Access Compliance Report

Public Rights-of-Way

Intersection ID: 45220	Main Street: ARDREY_KELL_RD	Cross Street: HARCOMBE_DR	Location: SW
ADA ID: 0315E4CE798B	Ramp Type: Perp	Initial Pass/Fail: Fail	Overall Compliance: No
		Severity Score: 10

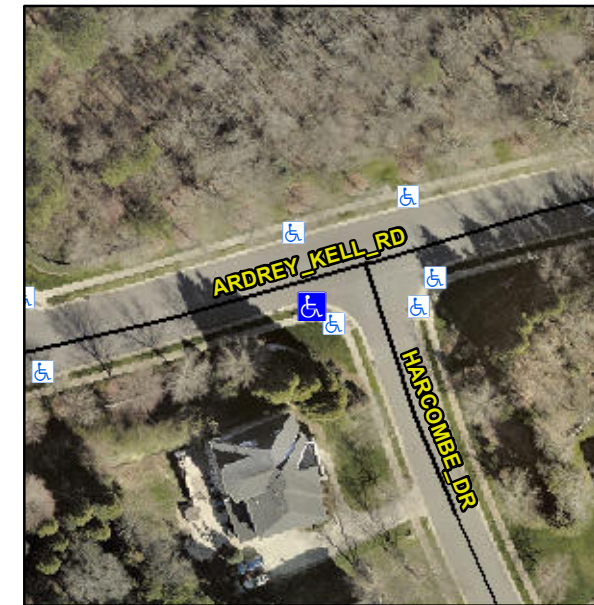
Not Found, R304.5.1

Compliance	Description	Data	Compliance	Description	Data
N/A	Ramp Length (in)	48.0	Yes	Ramp Slope (%)	8.0
No	Ramp Width (in)	43.5	Yes	Ramp XSlope (%)	2.7
N/A	Flare Type LT	N/A	N/A	Flare Type RT	N/A
N/A	Flare Slope LT (%)	N/A	N/A	Flare Slope RT (%)	N/A
N/A	Flare Traversable LT?	N/A	N/A	Flare Traversable RT?	N/A
N/A	Landing Length (in)	N/A	N/A	DWS Provided?	N/A
N/A	Landing Width (in)	N/A	N/A	DWS Contrast?	N/A
N/A	Landing Slope (%)	N/A	N/A	DWS Length (in)	N/A
N/A	Landing X Slope (%)	N/A	N/A	DWS Full Width?	N/A
N/A	Landing Curb? (Y/N)	N/A	N/A	DWS Offset (in)	N/A
N/A	Shared Landing?	N/A			
N/A	Gutter Ponding?	N/A	N/A	Gutter Slope (%)	N/A
N/A	Gutter Lip Ht (in)	N/A	N/A	Gutter X Slope (%)	N/A
N/A	Painted X Walk1?	No	N/A	Painted X Walk2?	N/A
	X Walk 1 Direction	To N		X Walk 2 Direction	N/A
N/A	X Walk 1 Width (in)	N/A	N/A	X Walk 2 Width (in)	N/A
	X Walk 1 Slope (%)	1.4		X Walk 2 Slope (%)	N/A
	X Walk 1 X Slope (%)	2.8		X Walk 2 X Slope (%)	N/A

Remove & Replace Entire Ramp.
